Updates to the simulation model

Apr 14 2021

Feedback from the engineering review

IP area and Targets

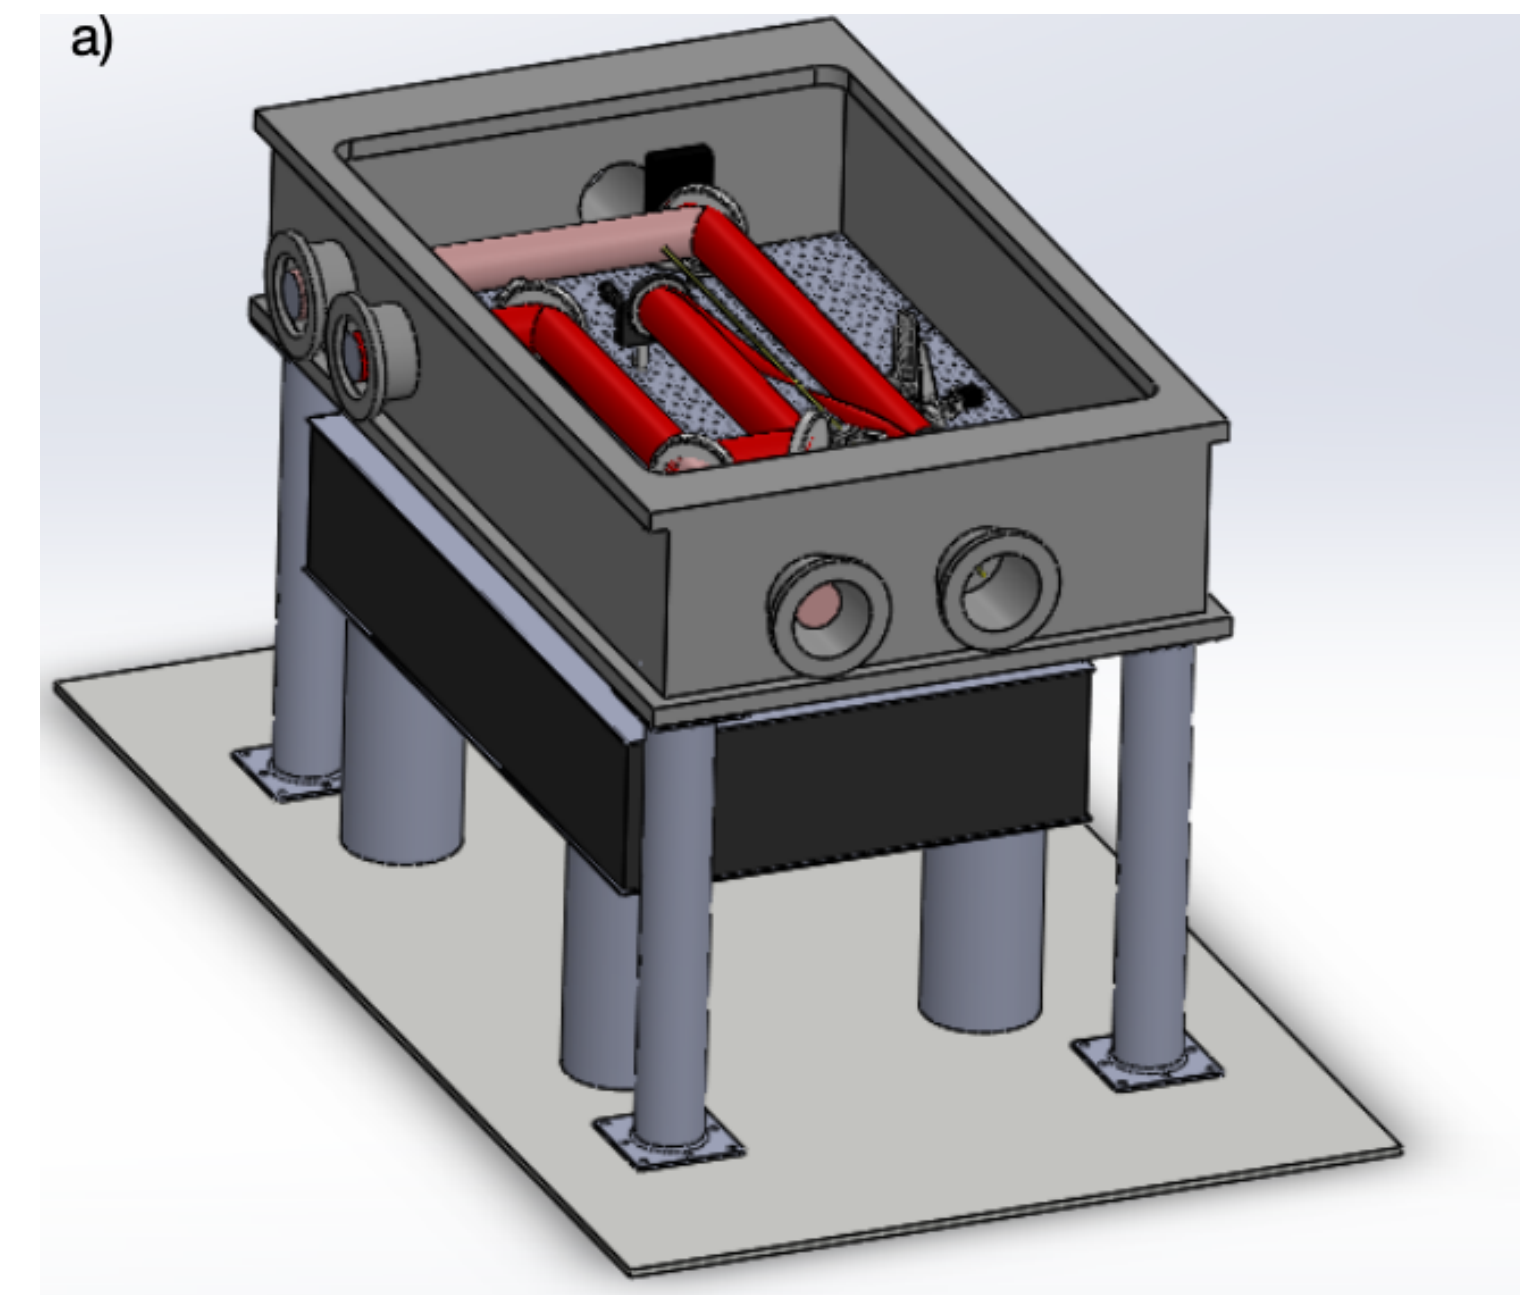
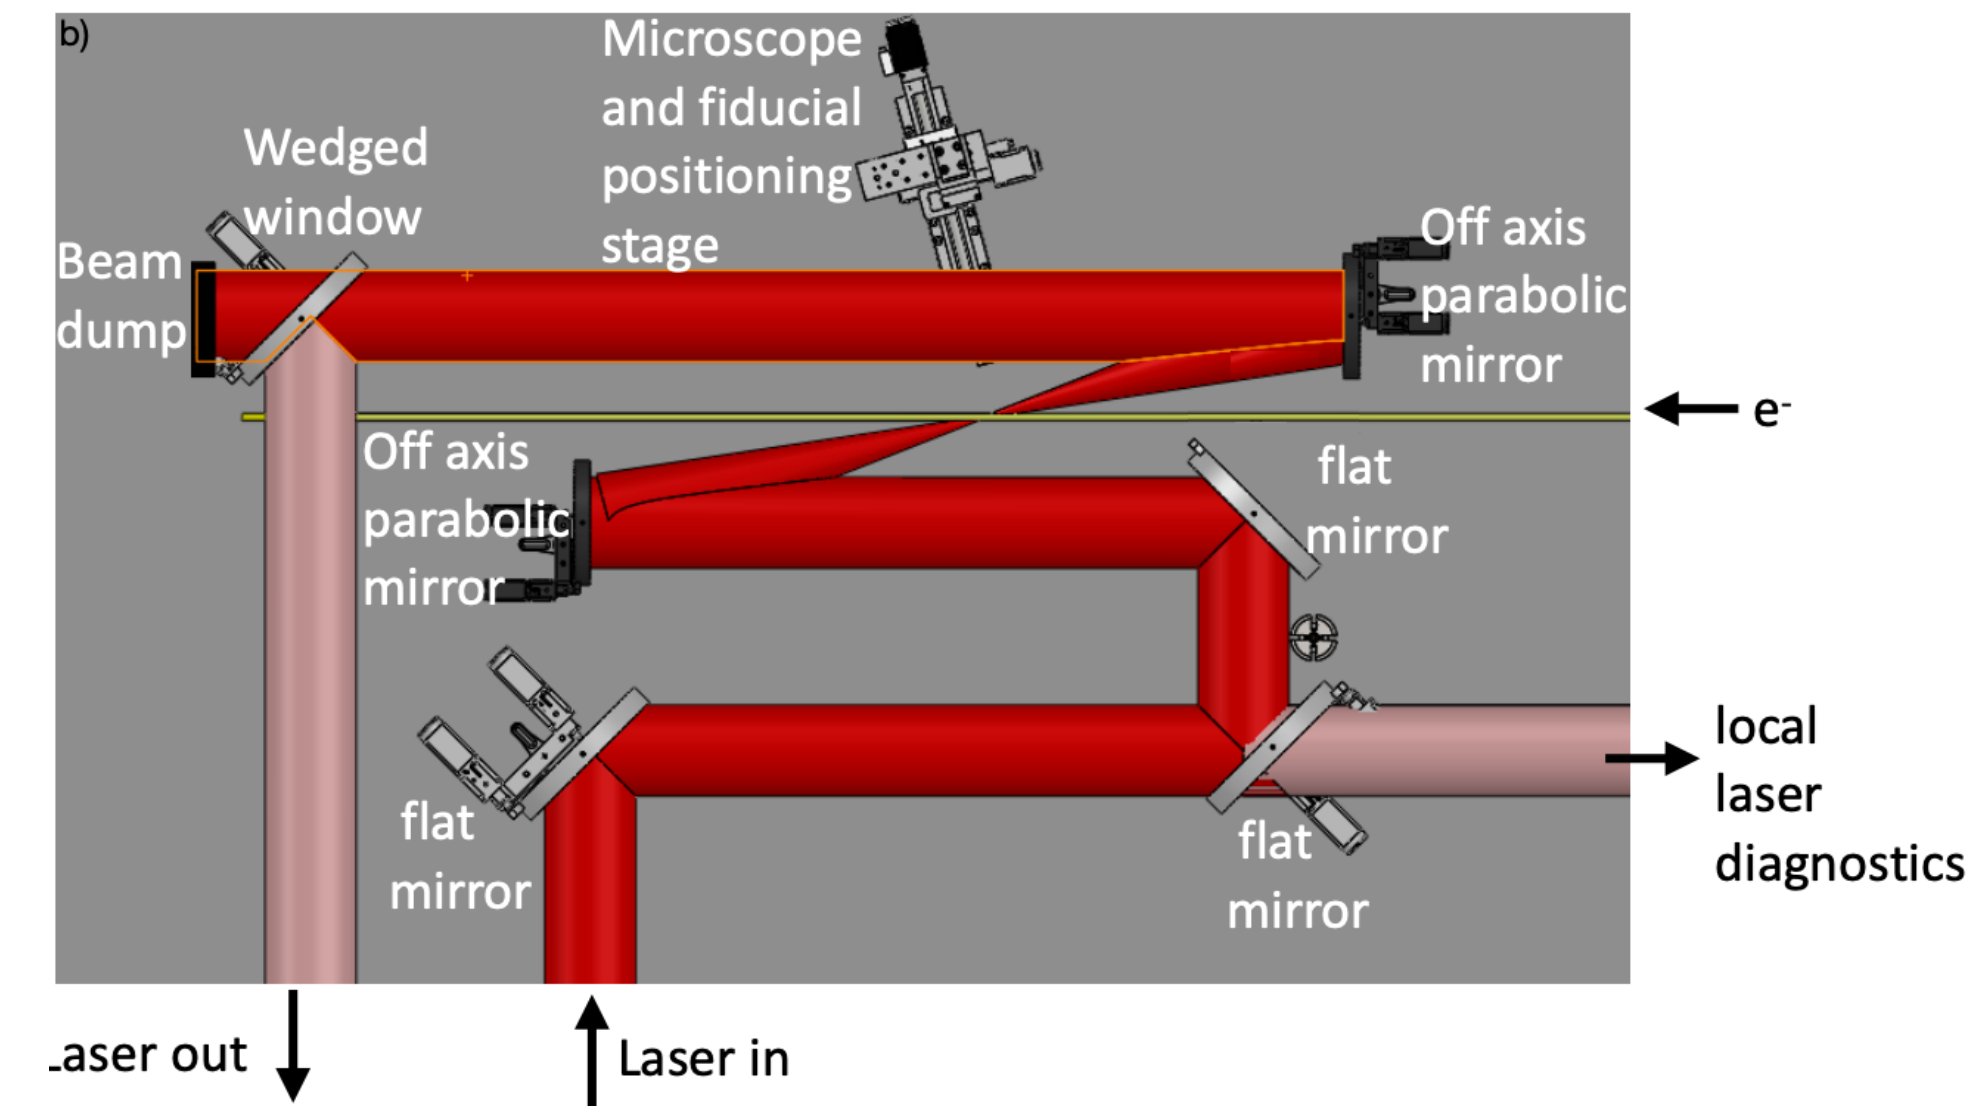
- ◉ Upstream area:
 - ◉ magnet is flipped: can it actually be supported like that by construction?
won't the foils be able to “drift”?
 - ◉ missing a model for the Cherenkov+Screen mechanics in the upstream part (vertical & tilted) and the IP part (horizontal)
- ◉ Targets:
 - ◉ no real designs of the target chambers (upstream and fwd)
 - ◉ how is the foil supported in the box?
 - ◉ should we be able to move the foil in the box (overheating and deformation)?
 - ◉ does it have to be cooled somehow?
 - ◉ can we have the upstream ICS box the same as the target chamber?
 - ◉ no supports in the model

Fwd area (see slide 4)

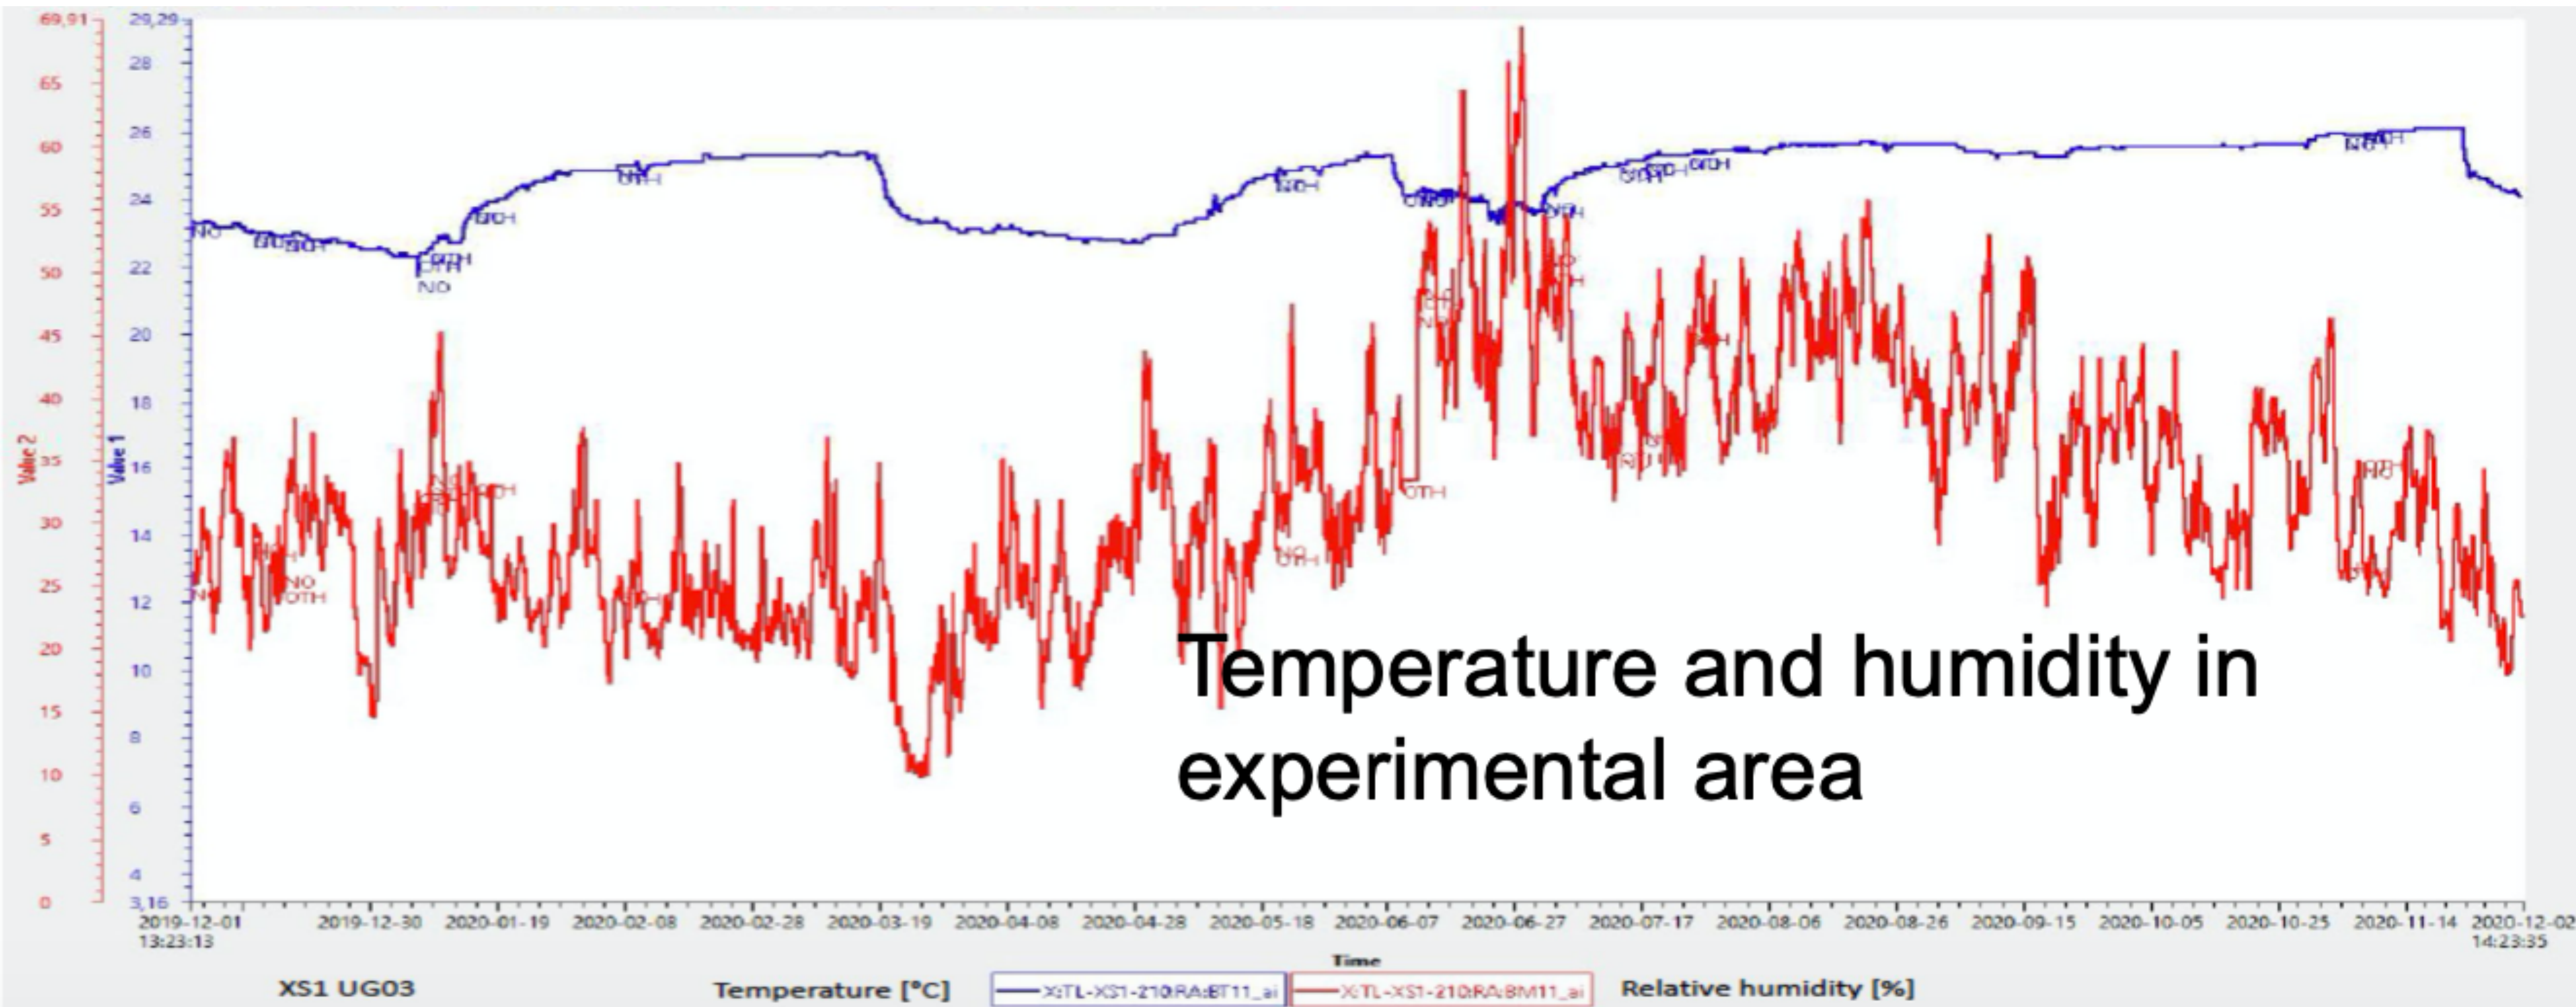
- ◉ check if we can move the fwd target a bit upstream (~ 0.5 m)
 - ◉ probably not, if we move the IP Screen+Cherenkov downstream...
- ◉ add the rectangular+triangular chambers with pumps
- ◉ add the profiler and make sure there's enough place to work between the fwd detectors and the shielding wall (now about 60 cm to end the vacuum of the beampipe and to put the profiler)
- ◉ add racks for the fwd detector, backscattering calo
